**Cornwall Solar Project
Renewable Energy Approval
Modification Report**

FINAL REPORT

October 16, 2020
revised February 17, 2021

Liberty Power has prepared an application to amend the REA to account for the replacement of the intermediate transformers which is designated as a Project Design Change.

Project No. 16101117
Drawing No. C-010

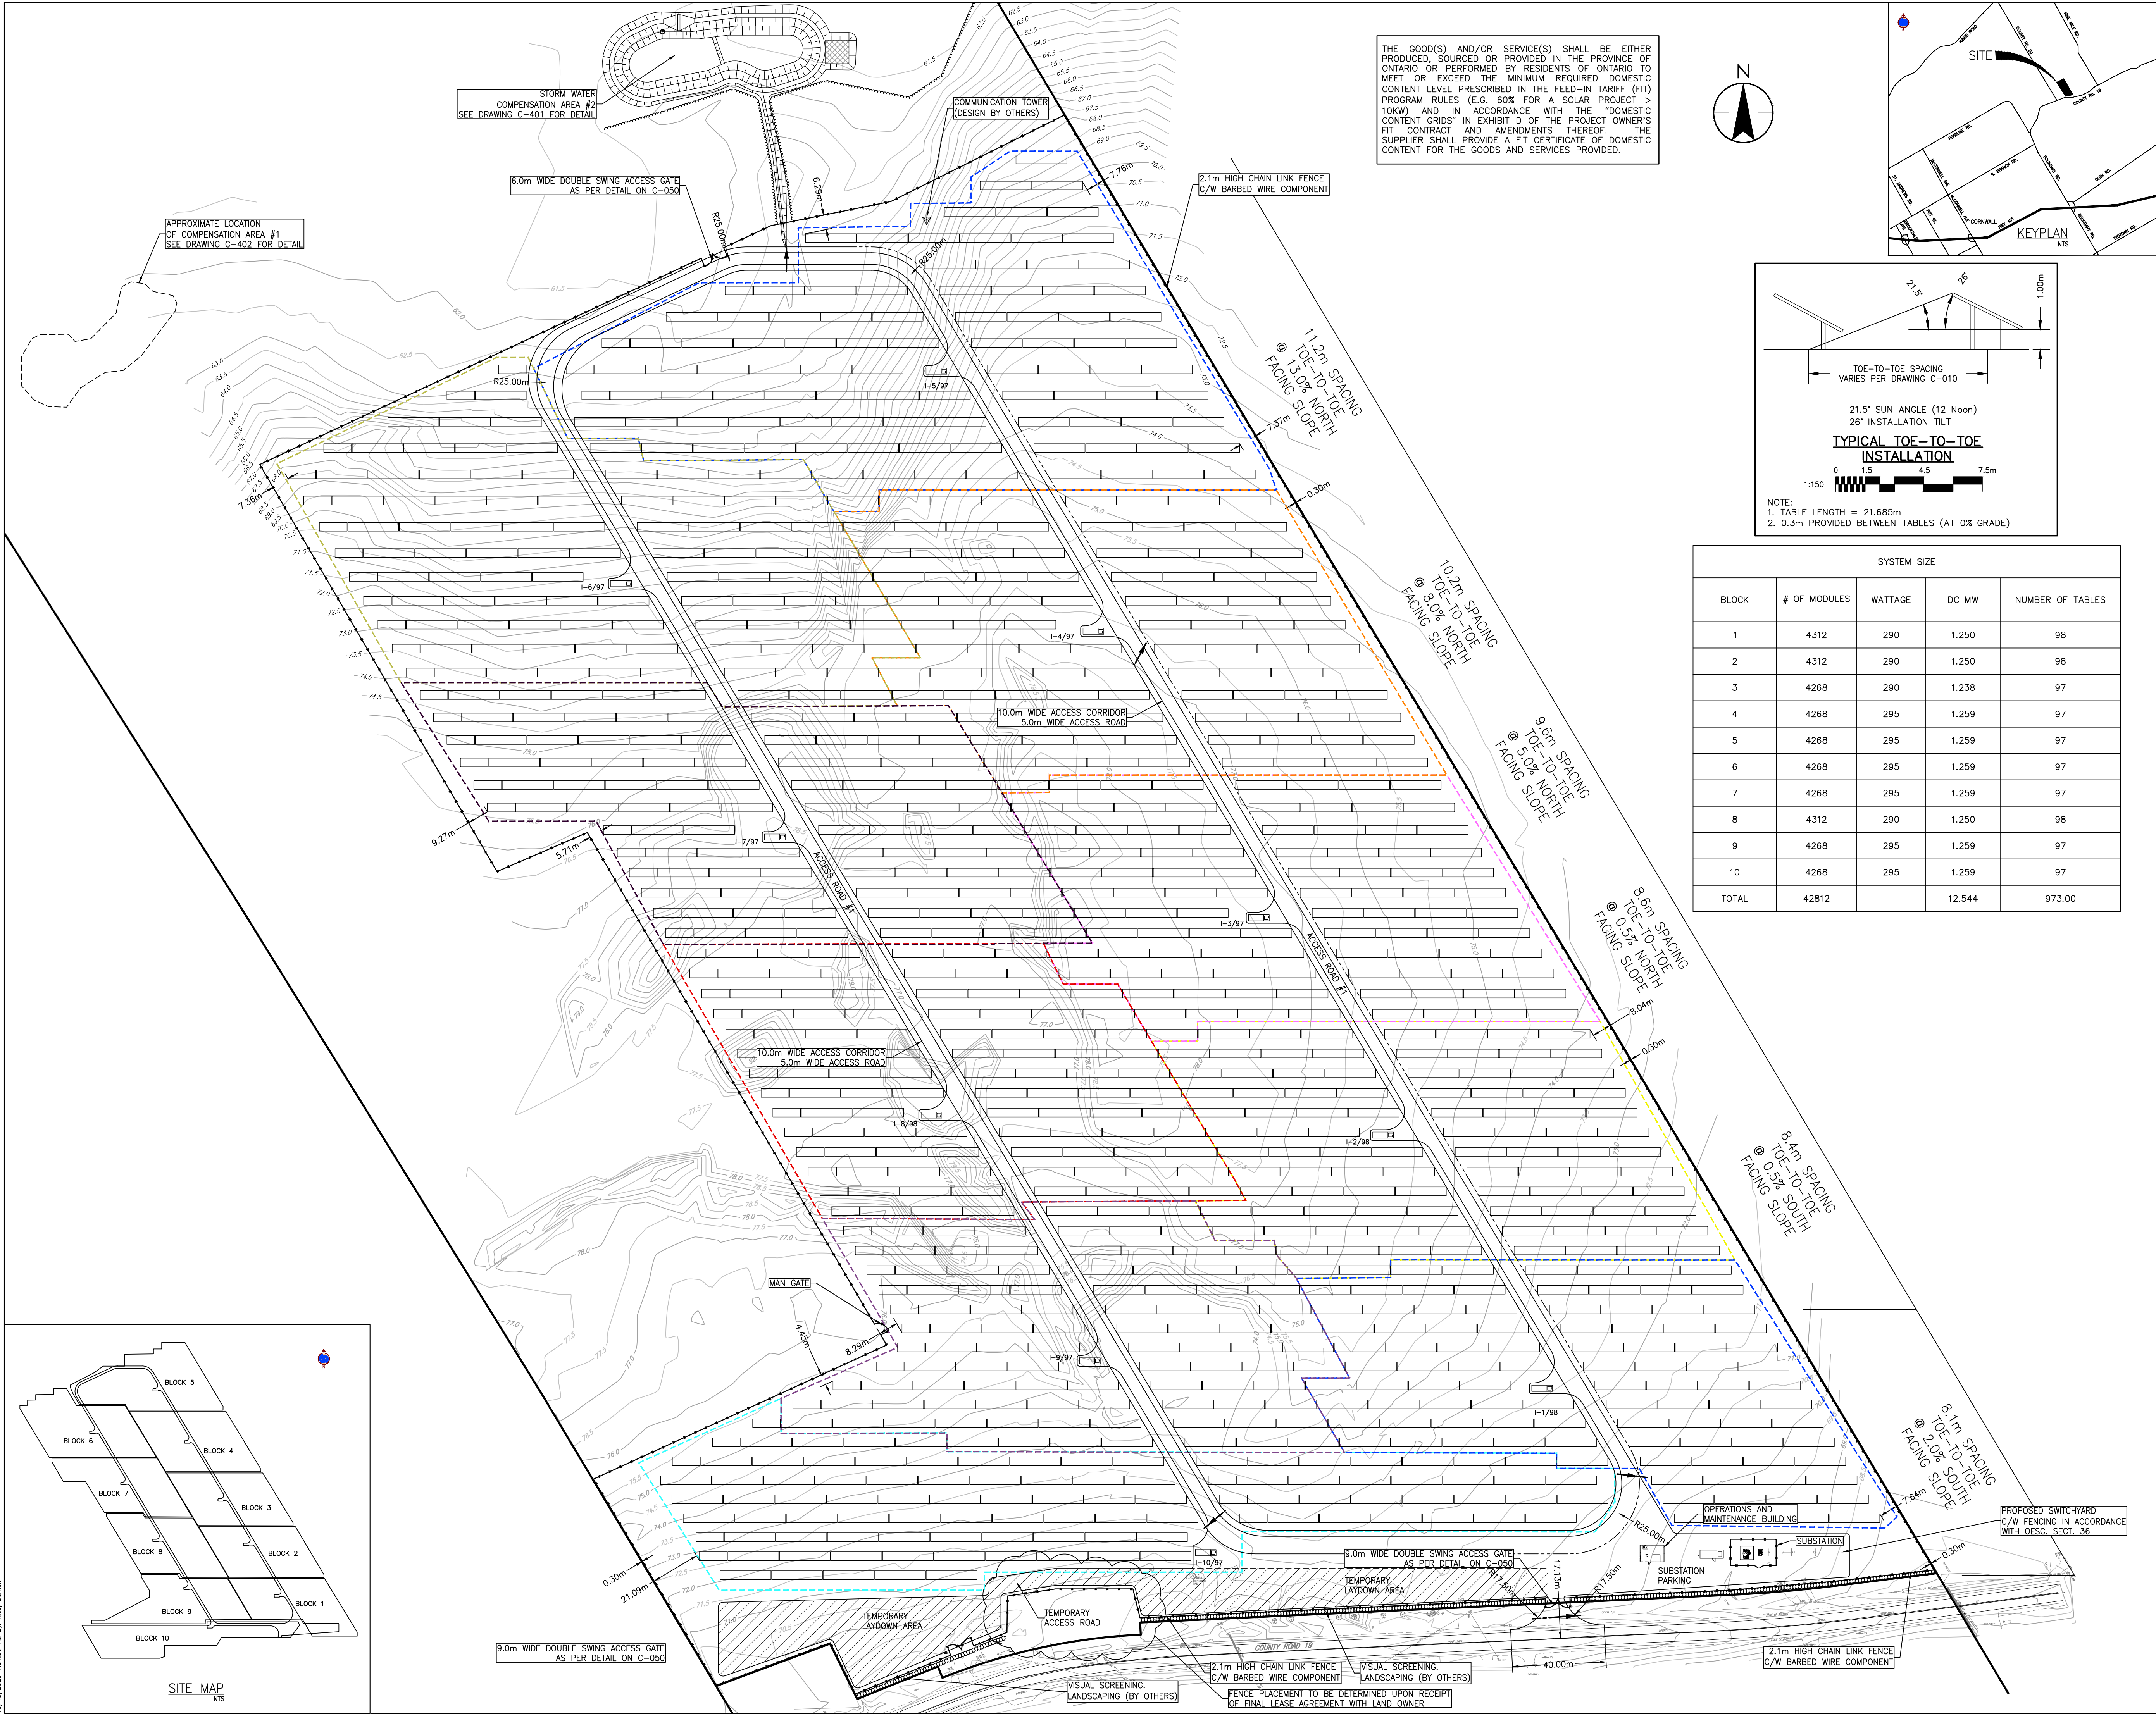
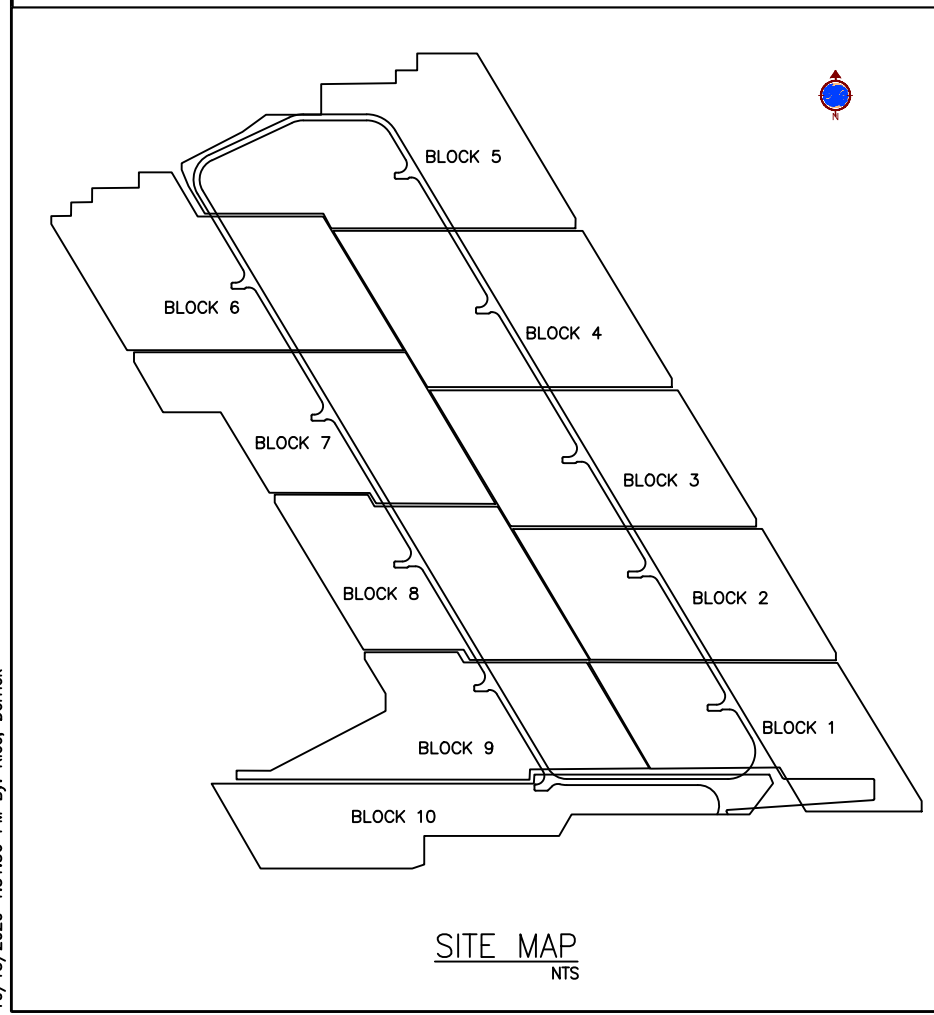
The proposed Project change entails replacing the existing ten intermediate transformers with ten new intermediate transformers in the same location to address an existing maintenance issue. The proposed replacement transformers will be installed on concrete slab-on-grade, which will not be replaced. The facility's total maximum name plate capacity of 10 megawatt shall remain unchanged.

The proposed layout and placement of transformers is provided in **Appendix A**.
